Proposal: Residential Flat Building
Property: No. 182-186 Gertrude Street, NORTH GOSFORD NSW 2250
Application No: DA 23/3021

I refer to your email of 2 May 2023 and provide the following comments on the exhibited development.

Figure 1: Extent on non-complying setback (Level 5)

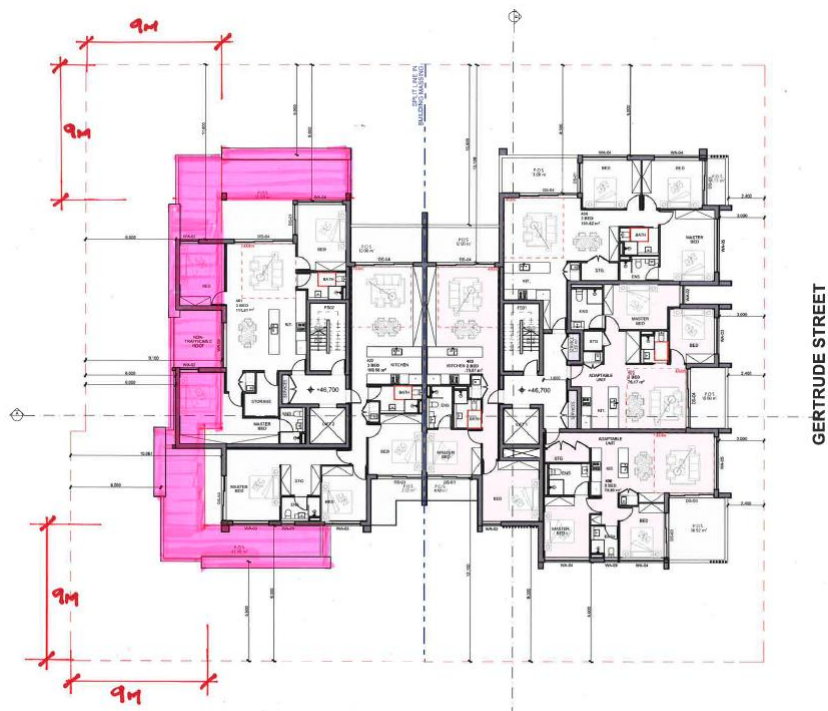
The ADG requires a 9 metre setback above 4 storeys including to balconies. The design proposes only 6 metres or 33% non-compliance on parts of the north, west and south. Non-complying setbacks result in visual and acoustic privacy impacts. It is acknowledged that the bedroom windows do not face the boundary, but they increase visual bulk and overshadowing and balconies are also non-complying resulting in privacy impacts to adjoining sites. This is a particular concern on the north and south where there is little significant planting to provide screening or outlook to and from adjoining sites.

Some minor non-compliance may be considered on the north if this is screened with significant landscaping as this does not result in overshadowing.
